Coastal Access Modification Report GAL-MR1

Proposed changes to the submitted England Coast Path proposals
for Gretna to Allonby

Location affected: **Burgh Marsh/Burgh-by-Sands, Cumbria**

9th May 2022

Map GAL-MR1f - Key Statutory Environmental Designations

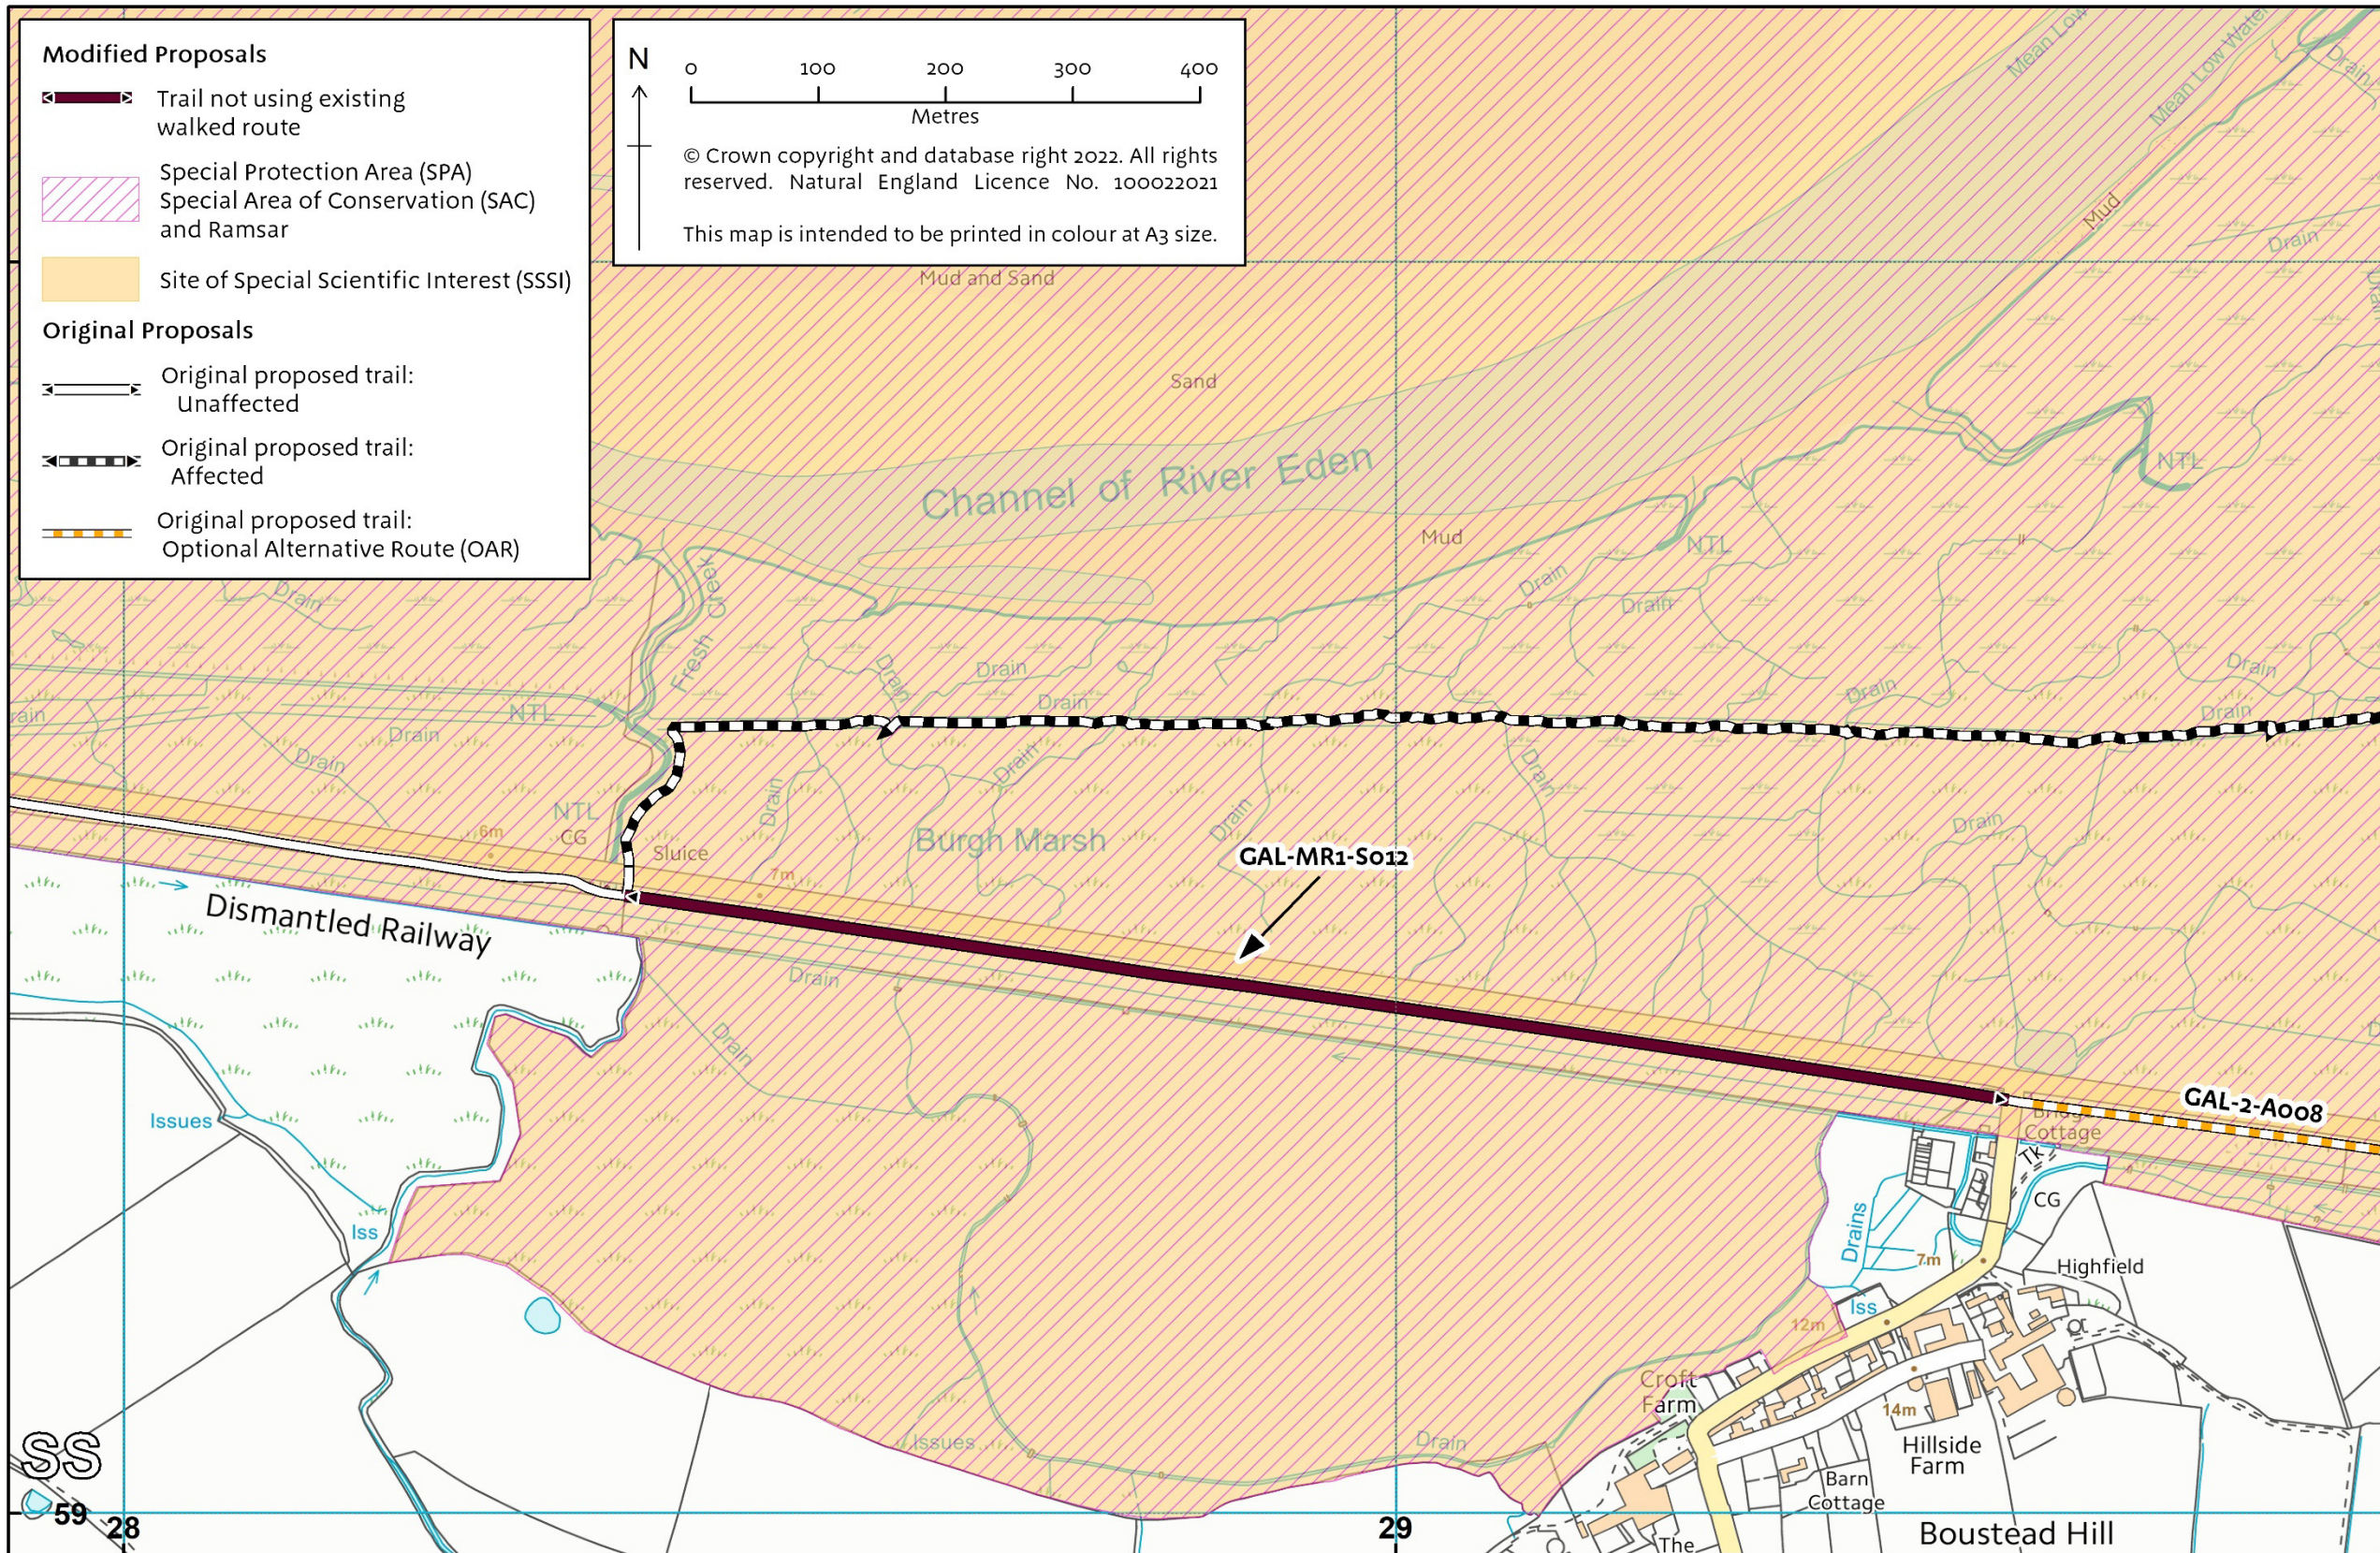
Refer to 'Key Statutory Environmental Designations' maps below – MR1d/1e/1f

A.2.5 The trail passes through saltmarsh habitat, which is a feature of the SAC/SSSI. This habitat can be sensitive to trampling damage. The modified proposals would reduce the amount of trail through this saltmarsh by approximately 1.9km, compared with the previously published proposals. The route has been designed to minimize the impact on the saltmarsh habitat by aligning on existing embankments or paths wherever possible. Small sleeper bridges (rather than culverts & path surfacing) would be installed in wet areas to minimize permanent loss of habitat and so that the route will not impact on the hydrology of the site. The area through which much of the modified trail would be aligned is predominantly grazing marsh, rather than true saltmarsh. The vegetation is robust and will withstand an increase in footfall.

A.2.6 Burgh Marsh is used by breeding and non-breeding birds, which are features of the SPA and Ramsar sites, and could be disturbed by walkers and dogs. The route has been designed to avoid areas frequently used by these features. Much of the modified route would be within a fenced corridor (for land management reasons); this will also reduce the risk of disturbance to any birds that are using the areas near the trail. The fencing will be maintained by the landowner. We have updated the HRA to include the modification.
